Office Action Summary	Application No.	Applicant(s)	
	10/632,017	ABELS ET AL.	
	Examiner	Art Unit	
	Ernesto Garcia	3679

DETAILED ACTION

JP2-199317, Yao

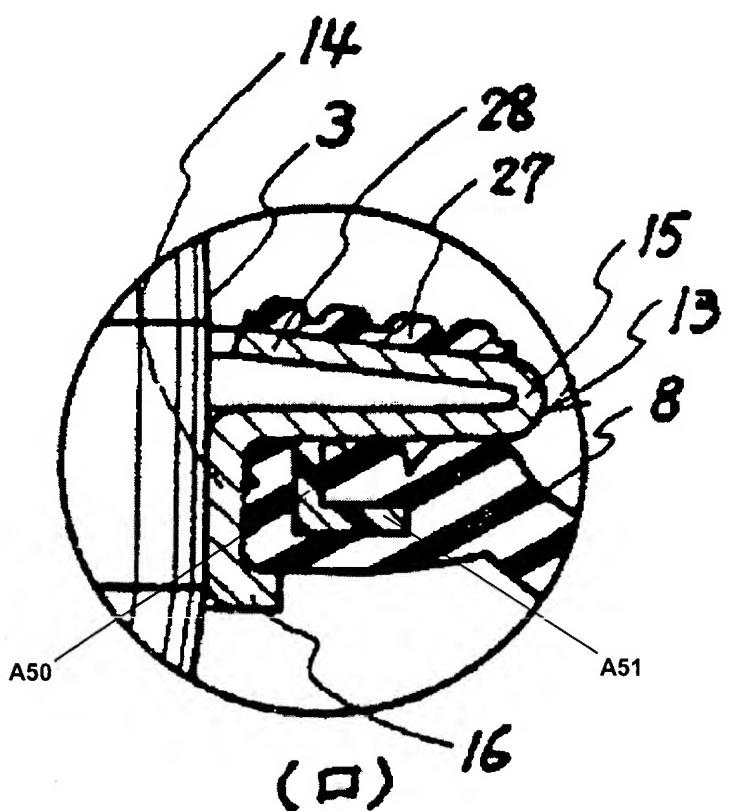
Claims 1, 5, 9, 10, 12, 14, 17, 20, 23, and 29 are rejected under 35 U.S.C. 102(b) as being anticipated by Yao, JP-2-199317 (see marked-up attachment in the last Office action).

Regarding claim 1, Yao, discloses, in Figures 1, 3 and 4, a ball-and-socket joint comprising a housing **6**, a bearing shell **5**, a ball pivot **2**, a sealing bellows **8**, a ball race **13**, and a sliding ring **A1**. The bearing shell **5** is inserted into the housing **6**. The ball pivot **2** with a joint ball **4** is pivotally mounted in all directions in the bearing shell **5**. The sealing bellows **8** is between the housing **6** and the ball pivot **2**. The sealing bellows **8** has a pivot-side edge area **23**. The ball race **13** is fixed on the ball pivot **2**. The sliding ring **A1** receives the pivot-side edge area **23** of the sealing bellows **8**. The sliding ring **A1** is mounted to slide in the ball race **13** and has a sliding face **A9** facing the joint ball **4** arranged adjacent to the ball race **13**. The ball race **13** has a leg **15** in contact with the sliding ring **A1**. The leg **15** comprising lugs **28** (Fig. 4) arranged at spaced locations from one another.

Regarding claim 5, the sliding ring **A1** includes an axial extension **14** and a radial extension **16**.

Regarding claim 9, the ball race **13** has an approximately U-shaped cross section.

Regarding claim 10, the sealing bellows **8** has a surface **A100** slidingly in contact with a surface **A20** of the ball race **13**.

Regarding claim 12, the surface **A100** of the sealing bellows **8** forms a labyrinth seal together with the surface **A20** of the ball race **13**.

Regarding claim 14, the sliding ring **A1** is a shaped sheet metal part or a plastic molding. The sliding ring **A1** receives and holds a portion of the sealing bellows **8** between the axial extension **14** and the radial extension **16**. The axial extension **14** and the radial extension **16** are substantially perpendicular to each other. The ball race **13** is fixed to the ball pivot **2**.

Regarding claim 17, the pivot-side edge area **23** of the sealing bellows **8** forms a thickened material bead pressed against the ball race **13** or the sliding ring **A1** with an elastic pretension.

Regarding claim 20, the sliding ring **A1** has an approximately L-shaped cross section.

Regarding claim 23, the sliding ring **A1** is vulcanized directly to the pivot-side edge area **23** of the sealing bellows **8**.

Regarding claim 29, the lugs include free ends (the free ends are occupied by feature **27**; Fig. 3, or the free ends could be at the bent **15** in Fig. 4). The free ends face away from the ball pivot **2** in a radial direction (note that Figure 3 shows a free end does not face when free end is perpendicular to the ball pivot **2**, but when unassembled, the free end faces at an angle thus away). Alternatively, the bent at **15** also faces away from the ball pivot.

Regarding claim 30, the Japanese patent, as discussed above, discloses the sliding ring **A1** having an L-shaped cross section comprising an axial leg **A50** and a radial leg **A51**. However, the radial leg **A51** is not in sliding contact with an inner surface of the ball race **13**. Gardner teaches, in Figures 2 and 3, a radial leg **27** in sliding contact with an inner surface of a ball race **23**, as part of an alternative configuration of mounting a sealing bellows to a ball race. Therefore, as taught by Gardner, it would have been obvious to one of ordinary skill in the art at the time the invention was made to make the radial leg in sliding contact with an inner surface of the

Regarding claim 31, given the modification above, the radial leg **A51** will be between the sealing bellows **8** and the lugs **28**.
